August 17, 2023

**Re:** Port Ewen Fire District

Port Ewen Firehouse Construction Project

### **Addendum #2**

SHEET:  
E010

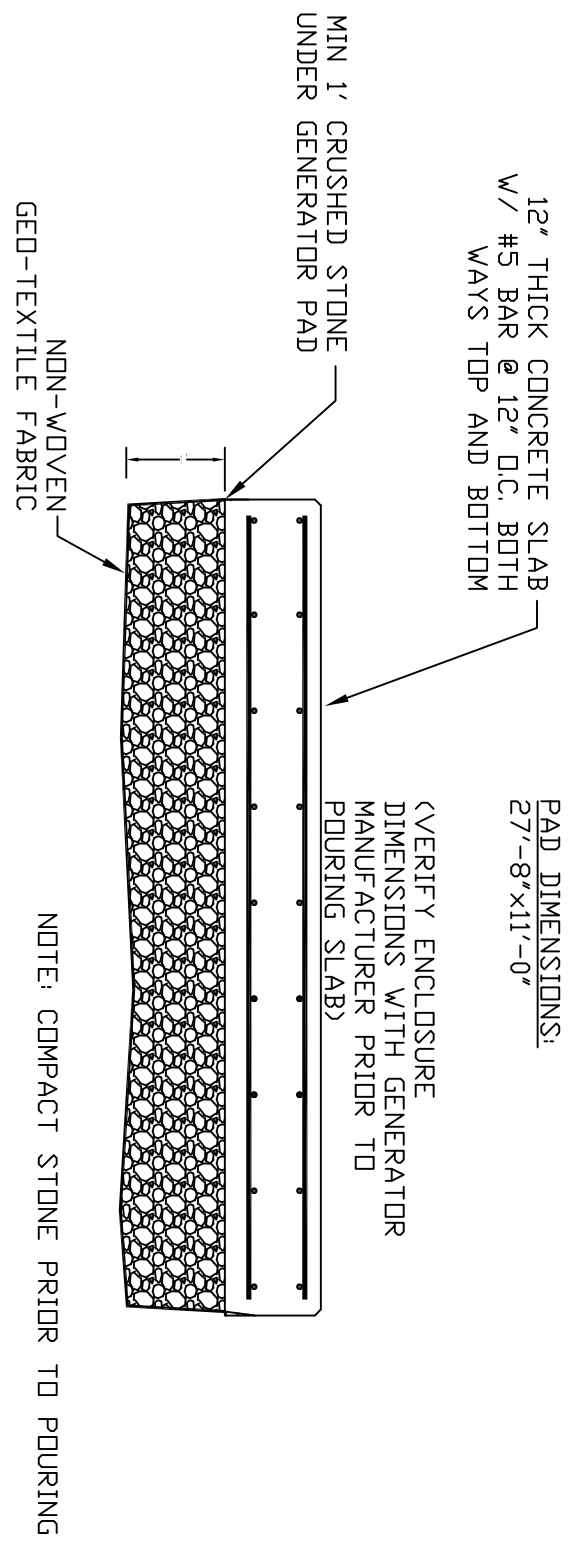
**ITEM #32: REVISION – CONTRACT #1E & #1H – Drawing E010**

- Added conduit H9.1.
- See attached plan with revisions.

SHEET:  
**E-012**

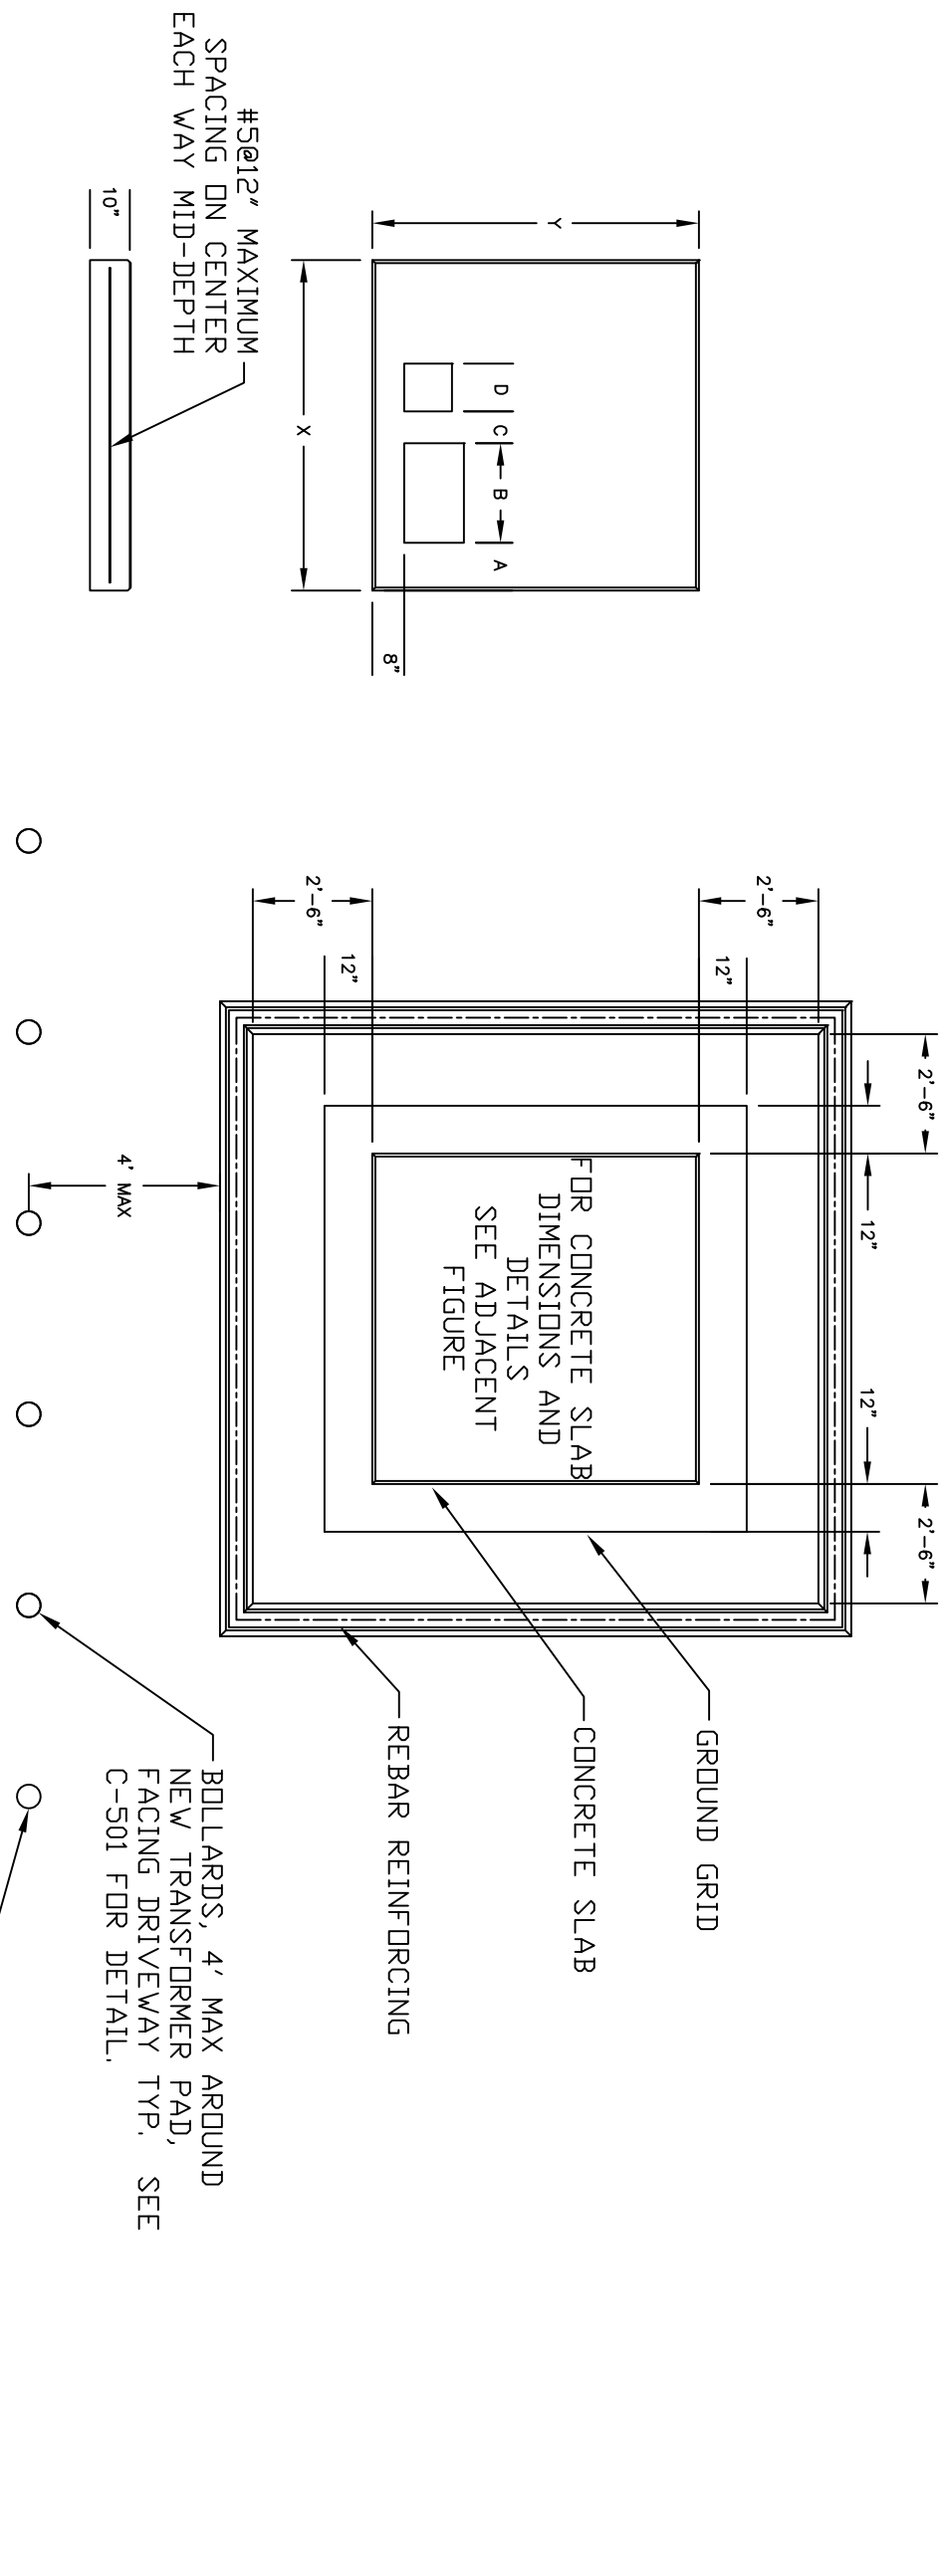
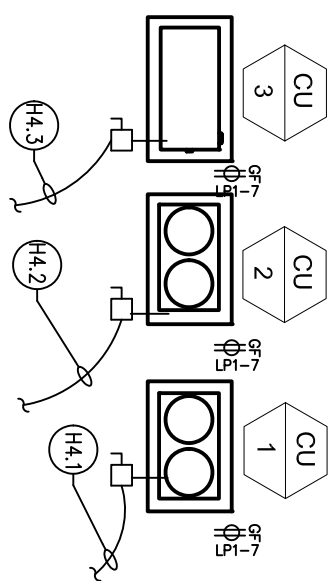
**ITEM #35: ADDITION – CONTRACT #1E – Drawing E012**

- Added a detail for the generator concrete pad.
- Added a detail for the utility transformer.
- See attached plan.

E103

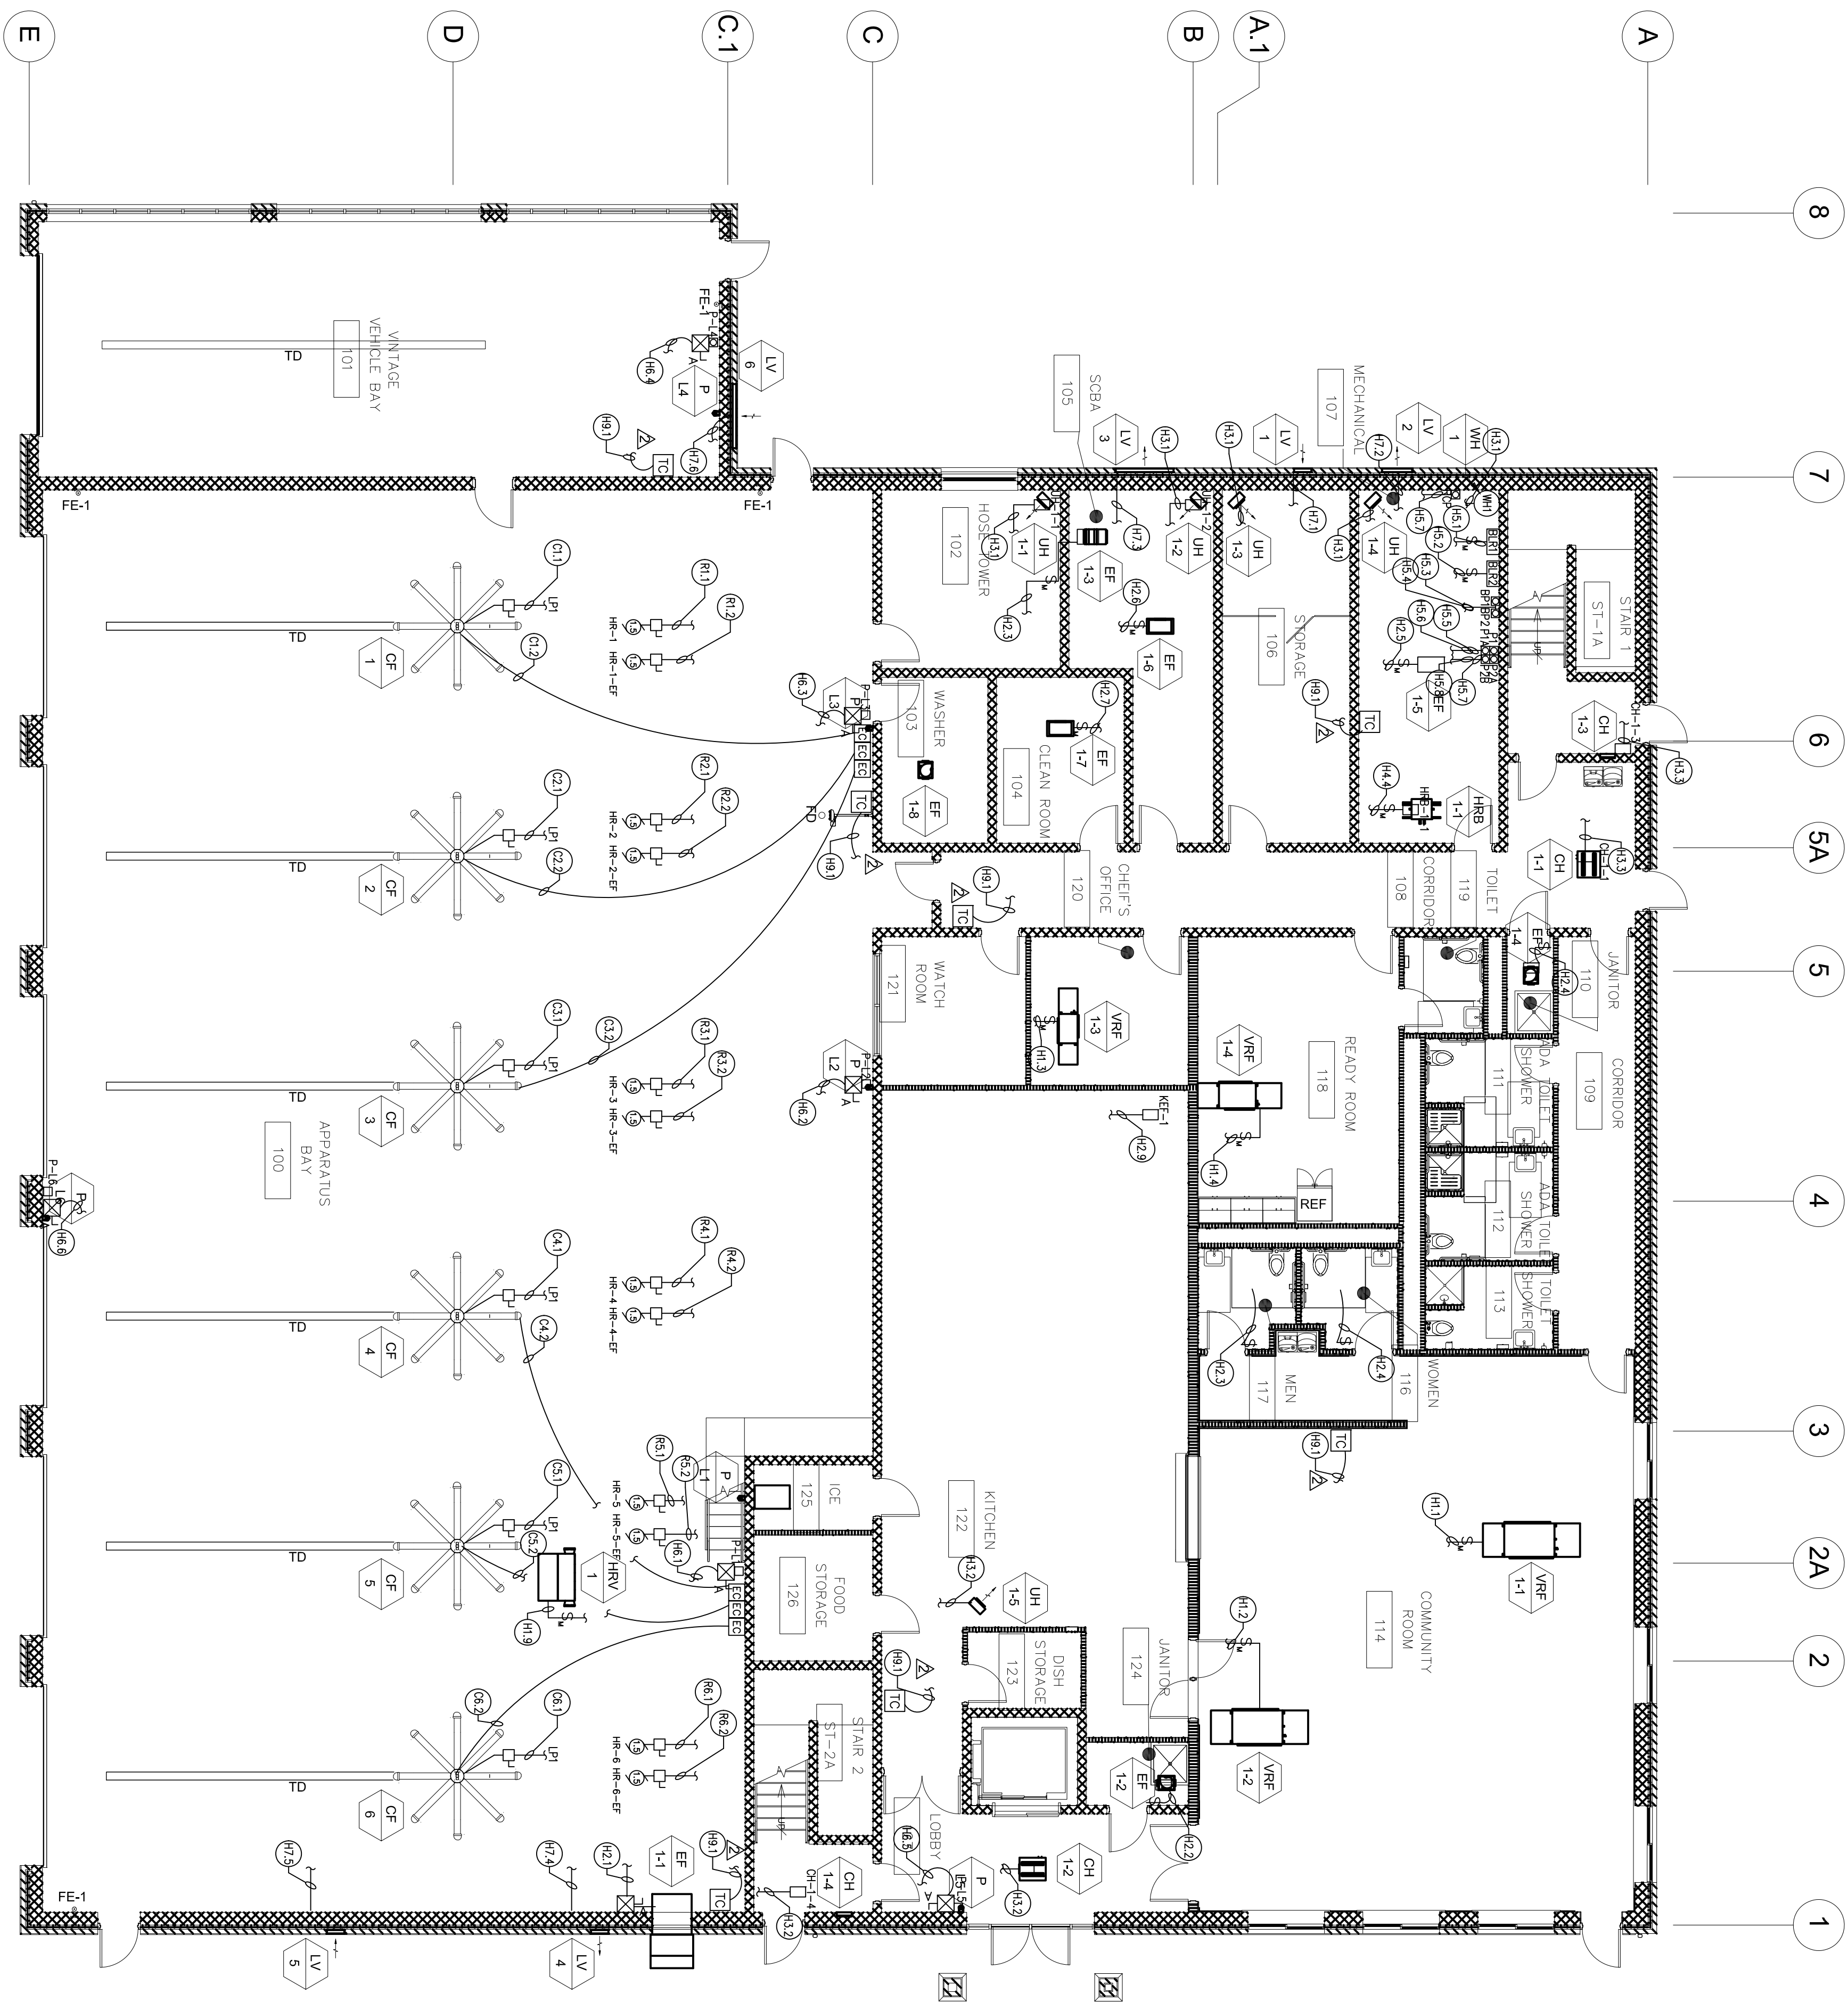
**ITEM #33: REVISION – CONTRACT #1E & #1H – Drawing E103**

- Added a location for the temperature controller junction boxes. The electrician shall run a 120V circuit to this location for the HVAC contractor to use for temperature control. The HVAC contractor shall run the conduit and conductors from this location as needed.
- See attached plan with revisions.

SHEET:  
**E203**

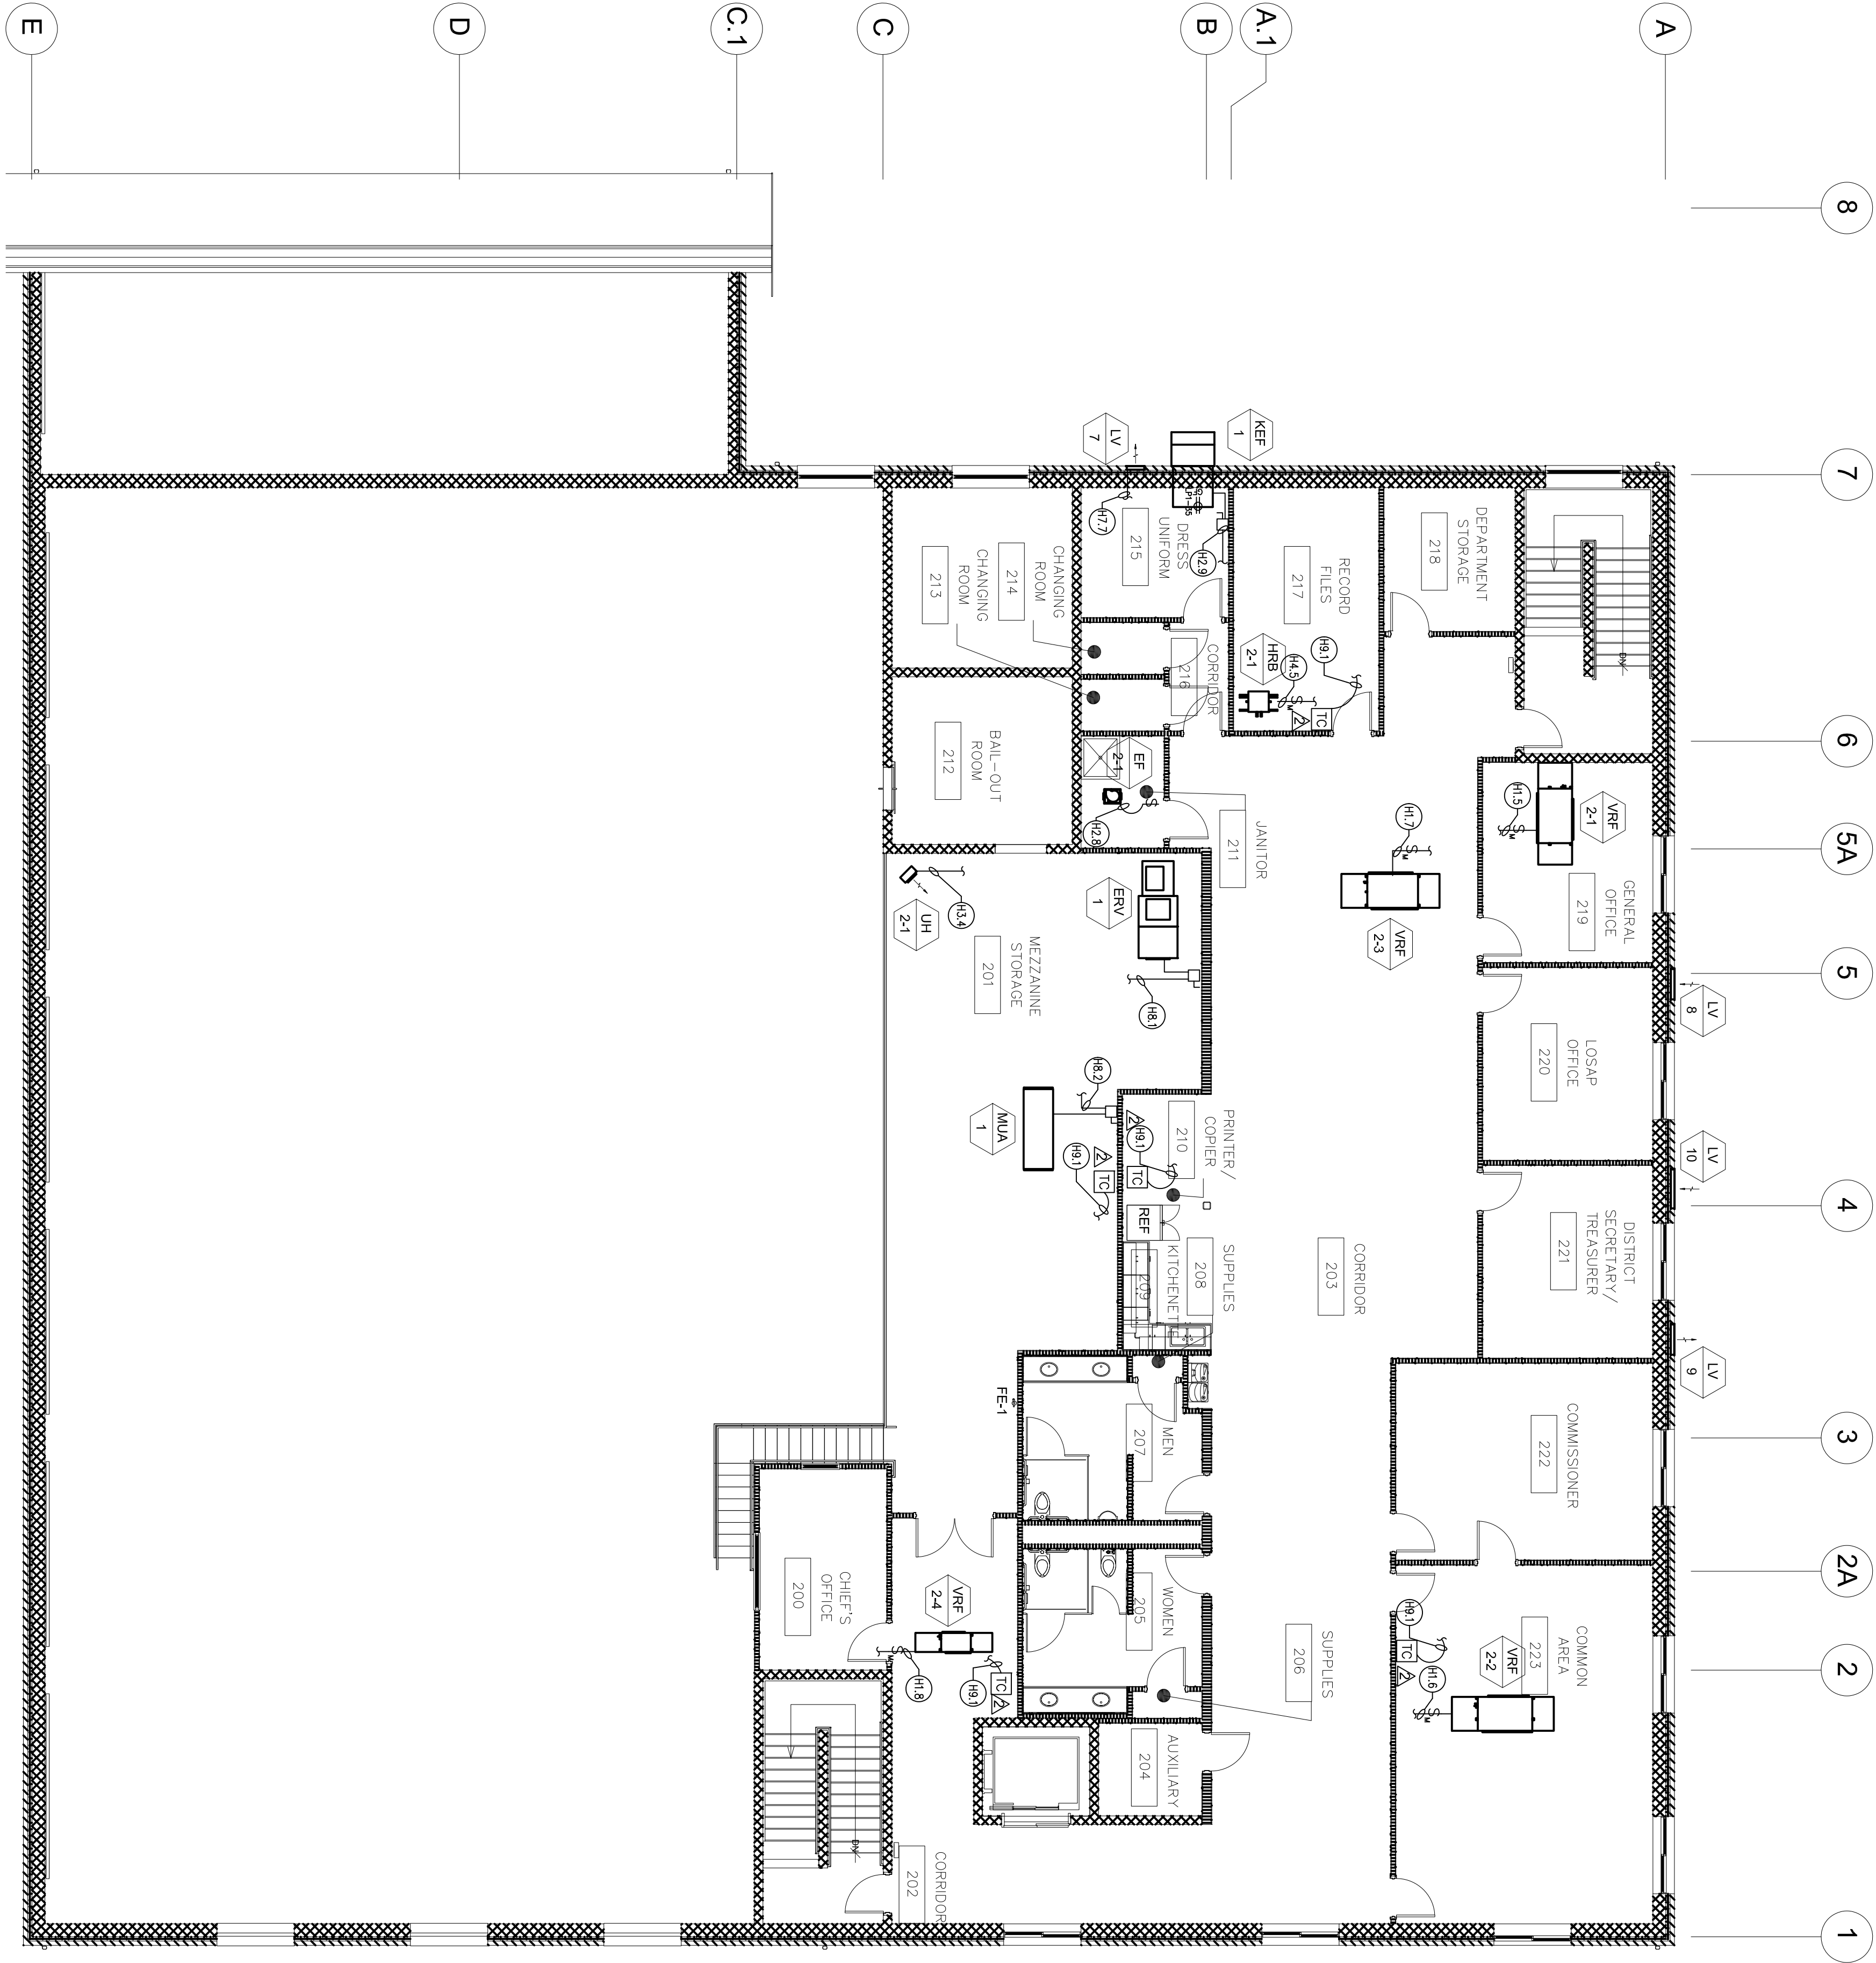
**ITEM #34: REVISION – CONTRACT #1E & #1H – Drawing E203**

- Added a location for the temperature controller junction boxes. The electrician shall run a 120V circuit to this location for the HVAC contractor to use for temperature control. The HVAC contractor shall run the conduit and conductors from this location as needed.
- See attached plan with revisions.
